## XLamp® XHP35.2 LED Product Change Notification

PCN Reference Number: PCN-06042  
Date Issued: December 6, 2023

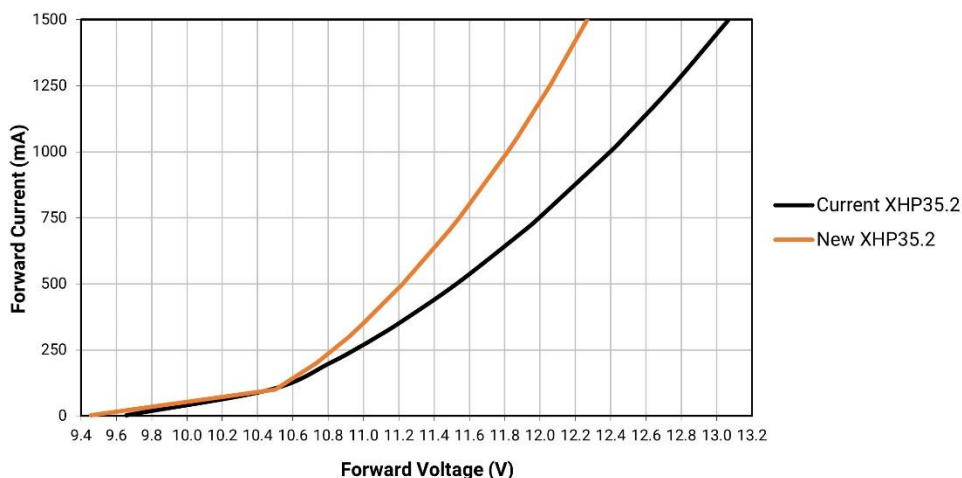
Cree LED will be changing the typical forward voltage for XHP35.2. Table 2 shows the current and new values.

Characteristic	Current Typical	New Typical
Forward Voltage	11.2 V	11 V

The following graph shows the changed Forward Voltage vs. Current curves.
